**111 Norton Way South
Heritage Assessment**

**RESPONSE TO HERITAGE FOUNDATION
STATEMENT OF CASE**

4th July 2019

111 Norton Way South (34451) – Ground floor rear extension

Letchworth, The Fenners building

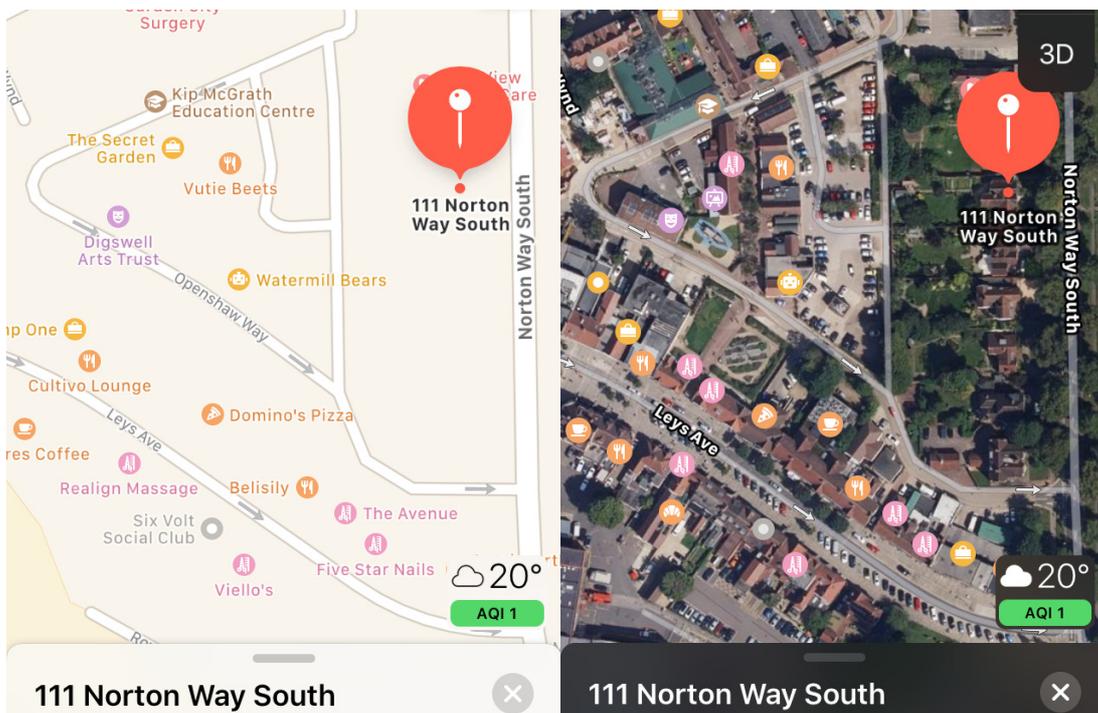
I would also like to highlight the fact that the Fenners building was converted with support from the Letchworth Heritage Foundation and has a shallow pitch tiled roof (almost the same pitch as that proposed for the extension at 111 Norton Way South). This should be sufficient justification that a shallow pitched tiled roof is acceptable to the Heritage Foundation.

I would suggest that the shallow pitch tiled roof is successful in both of these examples, the Fenners building especially is of architectural merit.
